**TAURANGA LANDSLIDES: 18 MAY 2005
SITE VISIT & REVIEW NOTES**

Tauranga District Council
Private Bag 12022
Tauranga

Version: 10005.2.1
Date: 13 July 2005

Figure 1: 18 May 2005 rainfall compared with 1977 to 1998 at Chapel St

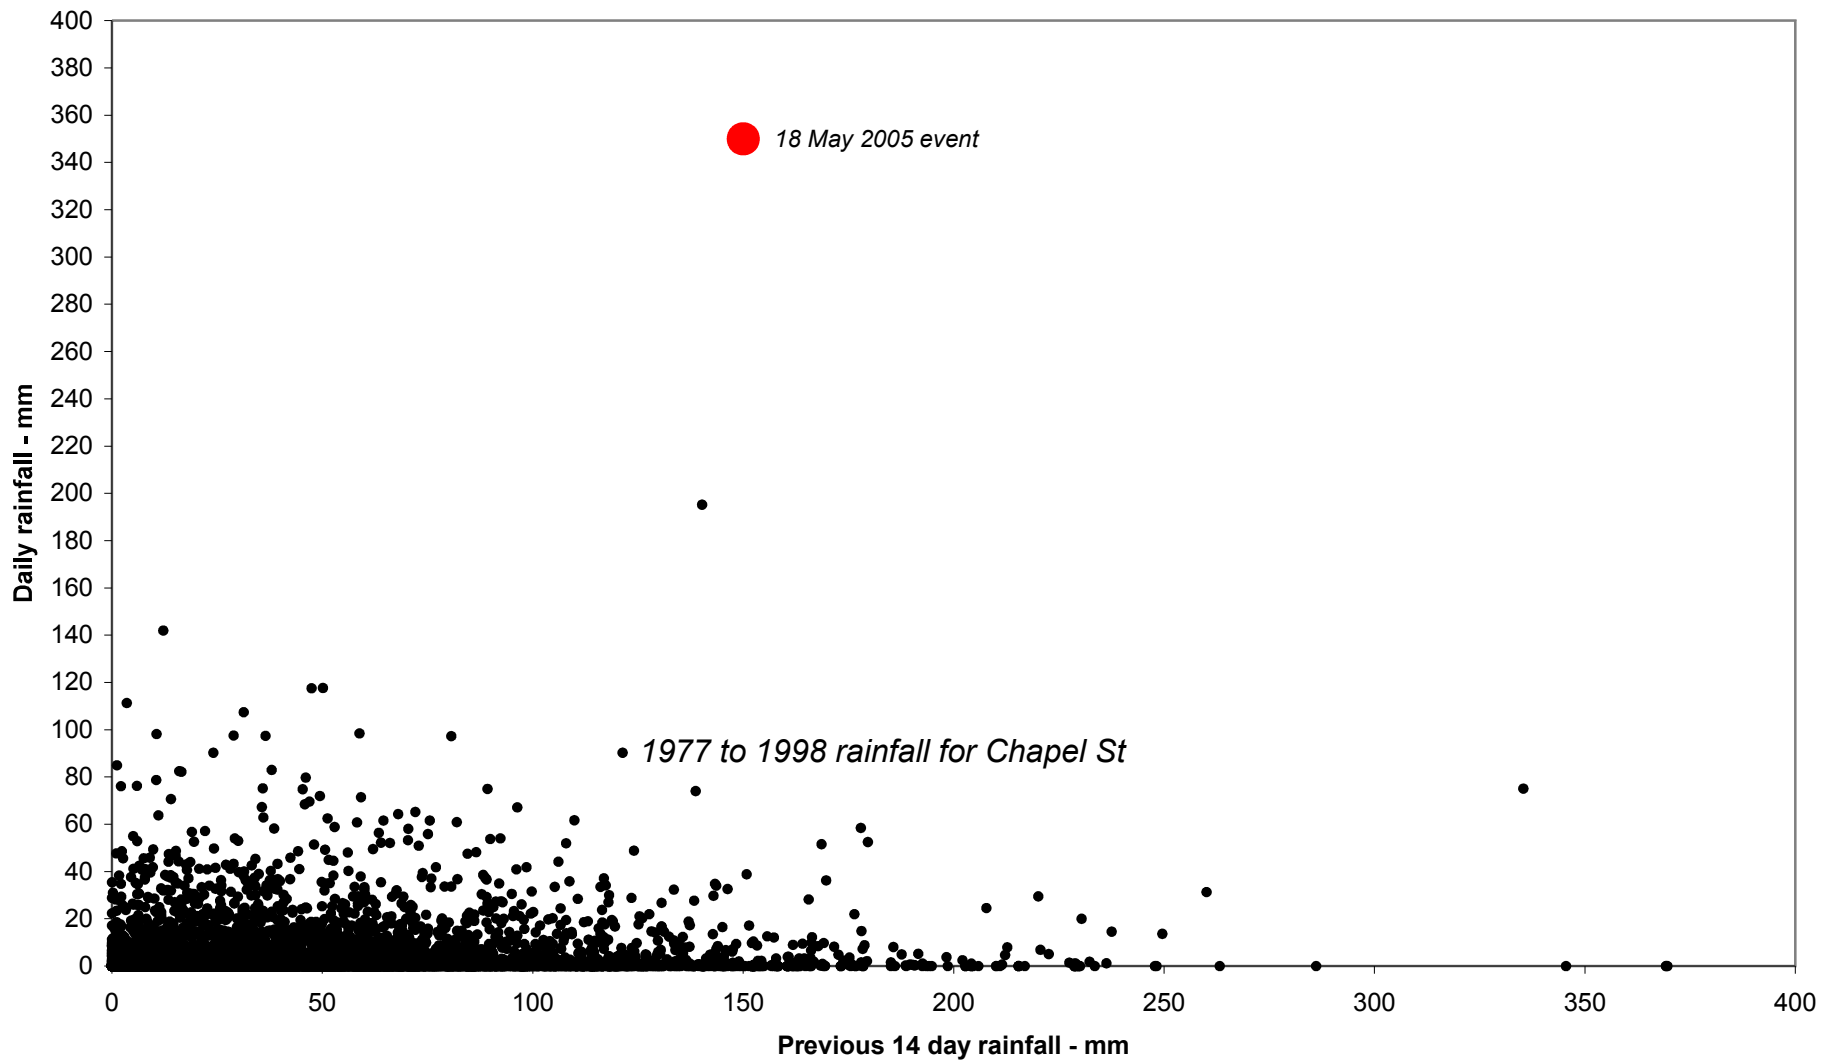
3. Local residents report considerable variation in rainfall and flooding over the city area during the 18 May event. The rainfall has been assessed as a 1 in 150 year event or greater. The effect of rainfall on the stability of slopes can be quantified by considering the total rainfall on the day of the event together with the cumulative rainfall over a previous number of days³. *Figure 1* shows the 18 May 2005 rainfall in comparison with the rainfall data at Chapel St from 1977 to 1998 (as used for the 1999 Mauao stability assessment⁴). The combination of daily and precedent rainfall exceeds any for the period from 1977 to 1998 and probably for the entire period of record in Tauranga.

2. The triggering event for the landslides was unprecedented rainfall leading to failure of the stormwater drainage system and uncontrolled overland flow. NIWA's Autumn 2005 climate summary indicates unprecedented rainfalls at Tauranga Airport on and prior to 18 May:

Figure 2: Example of landslide geometry at § 7(2)(a) - Privacy
TAURANGA MAY 2005 LANDSLIDES

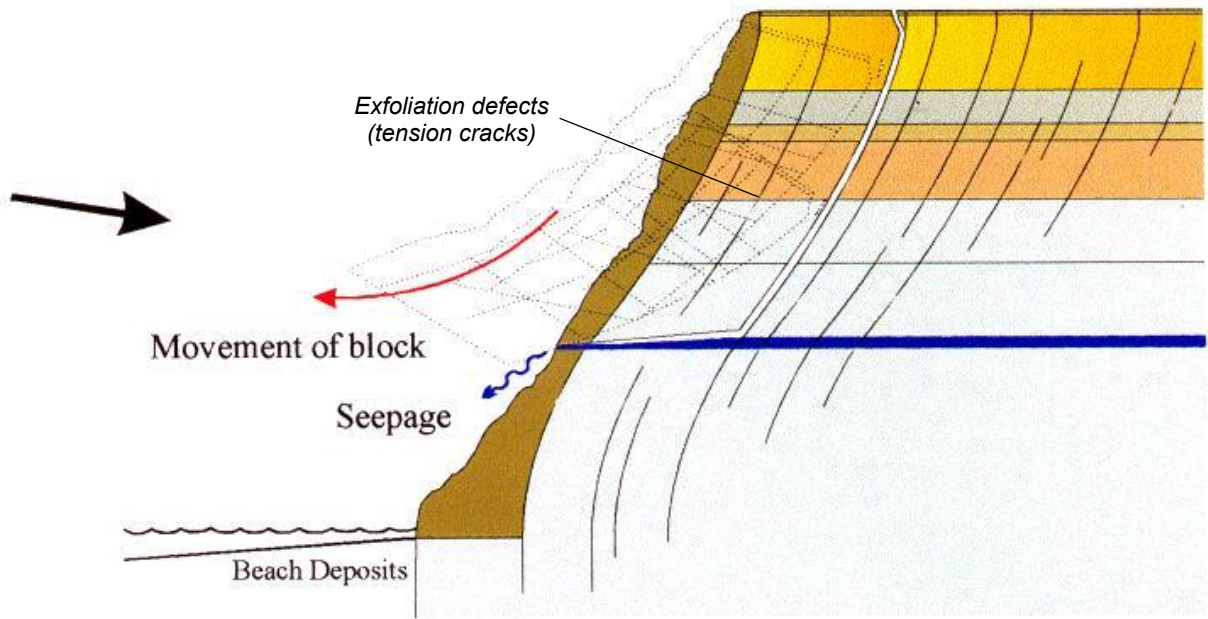
4. The slides inspected were notable for a number of features as follows (see *Figure 2*):
 - The heads of the slides are generally close to the slope crest and often controlled by changes in slope cover such as buildings or sealed areas

- The back faces of the slides are often controlled by near vertical discontinuities or tension cracks
 - High water pressures in these tension cracks have the effect of causing slide "blowouts" which would have initiated regardless of the inherent soil or rock mass strength

- The slide bases are controlled by less-permeable, low-strength ash horizons. The orientation of these layers (horizontal or dipping out of the slope) affects the size and geometry of the slide

- Water pressures in the slopes would likely have been high because of the wet autumn but the high joint pressures developed from surface infiltration would have resulted in significant failures even with low groundwater pressures

- Landslide runout was generally within a 4H:1V line projected from the headscarp. Most of the damage to houses was caused by runout rather than subsidence effects.

Figure 3: Slide morphology described by Oliver 1997

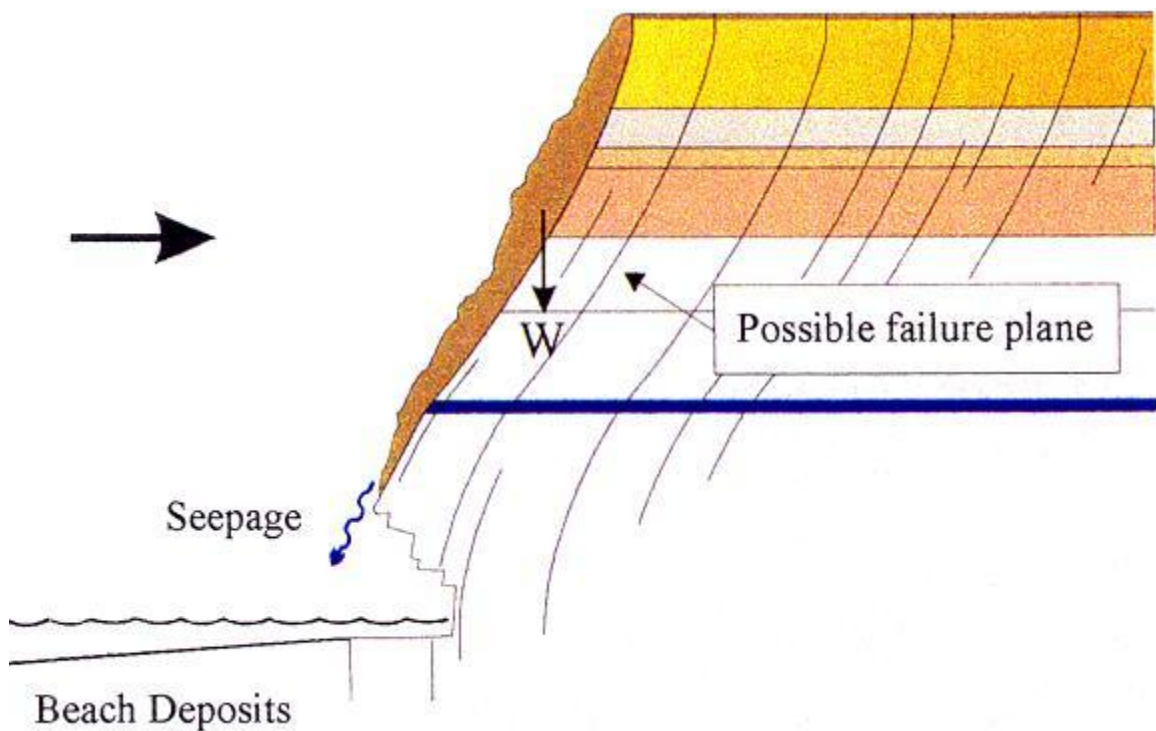
The presence of tension cracks is critically important to these slides. Such features have previously been identified by Oliver⁵ (*Figure 3*) who referred to these as *exfoliation defects* rather than the more appropriate terminology of *tension crack* or *stress-relief defect*. These features have a significant effect on slope failures since their orientation precludes any significant frictional resistance along the features, and the water pressure in the open joints can exert high horizontal pressures on the slide mass.

Figure 4: Slide with low groundwater level on ash layer

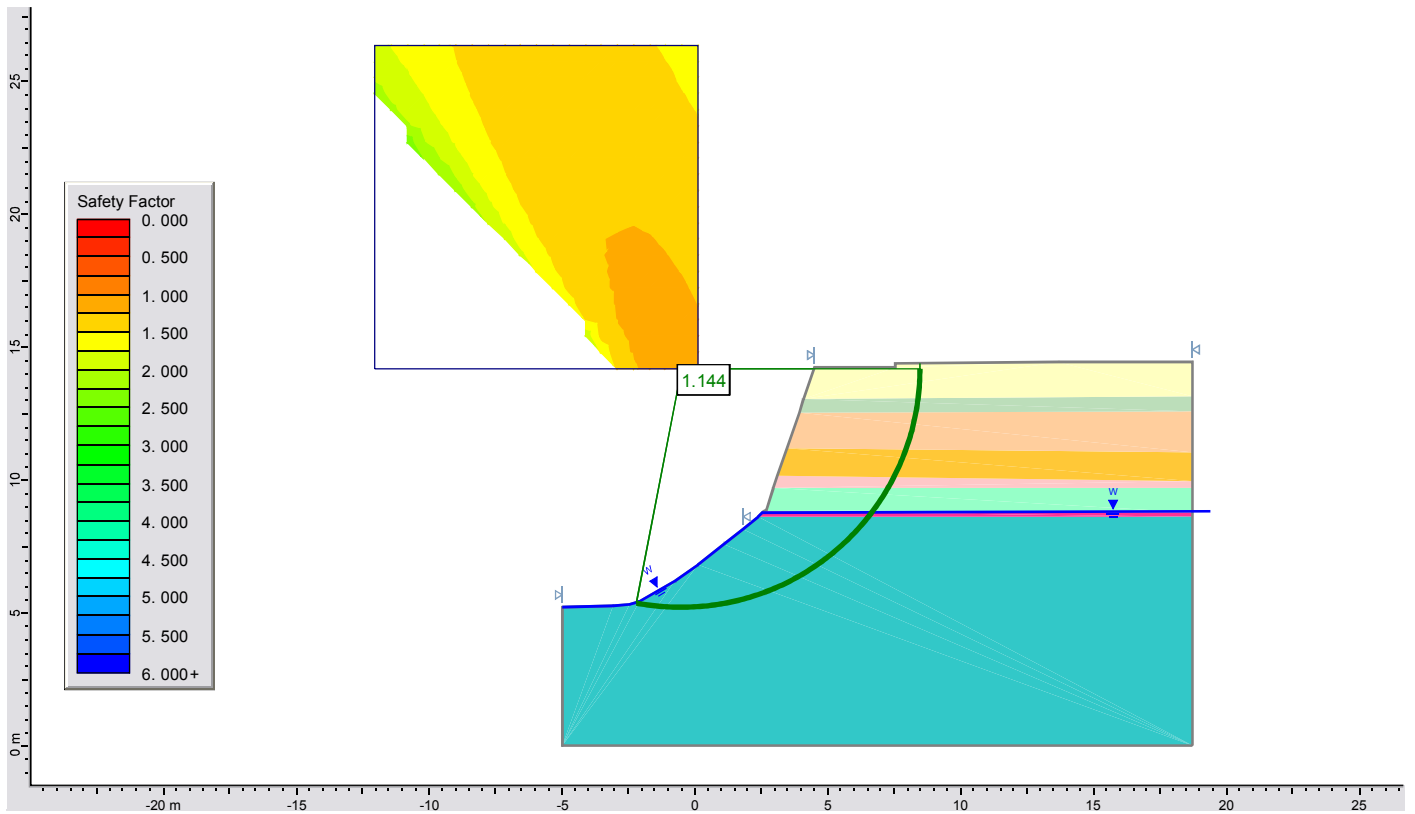
5. Without tension cracks or other structural controls present, the critical failure mode in these types of materials would be fairly deep-seated circular failures (see *Figures 4* and *5*) regardless of the level of the groundwater table. With water-filled tension cracks (*Figures 6* and *7*), the Factor of Safety (FOS) of the slope is significantly reduced and the critical failure surface moves closer to the slope crest for all groundwater conditions. Note that the above analyses are fairly simplistic since the toe of most failures is generally at the ash horizon.

Figure 8: Piezo locations and slope water pressures
TAURANGA MAY 2005 LANDSLIDES

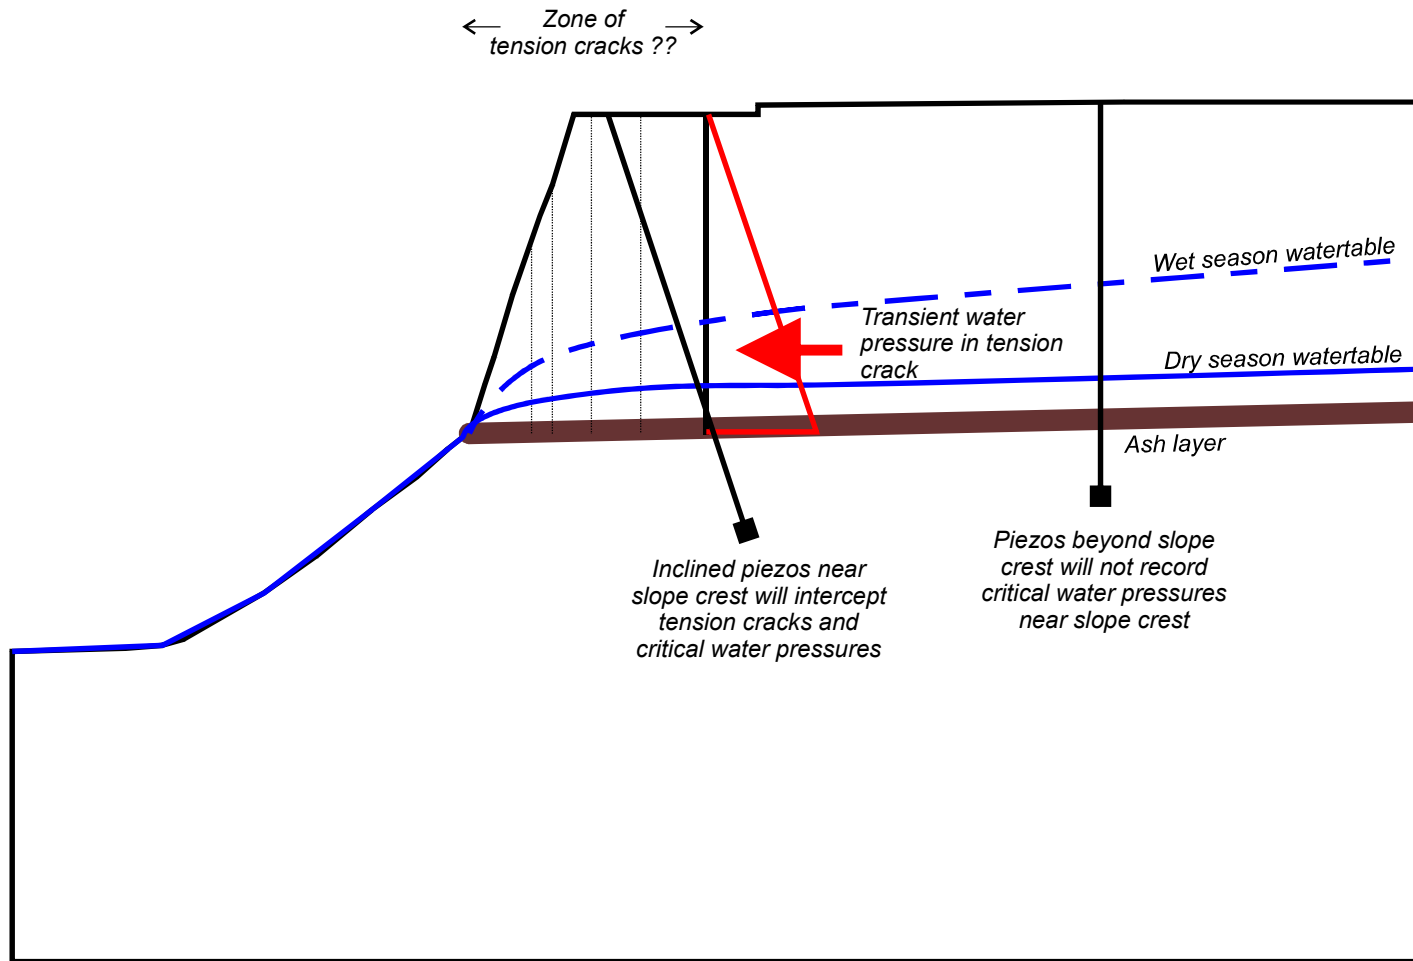
10. Very little is known about the response of these tension cracks to rainfall events (i.e. crack water pressure versus rainfall relationships). These features are most critical nearest the slope crests. Piezometers placed at some distance from the slope crest (measuring pore pressures within the slope) may give little indication of critical water pressures near the crest. Piezometric monitoring needs to take account of the tension cracks – this is likely to result in piezometers being placed in inclined drillholes to ensure interception of the tension cracks (*Figure 8*). Given the aerial variation of rainfall, automatic rainfall gauges should be located close to all automatic piezometer locations.

18. Piezometric monitoring should be established to identify critical water pressures near the slope crests. Automatic rainfall gauges will be required in the general area of the piezometers.
19. Any further proposals for slope monitoring should be reviewed in relation to the slope failure mechanisms and the instrument capabilities.
20. Conclusions arising from the review of these slides should be used to review TDC land development criteria and made available to all those concerned with development in this area.
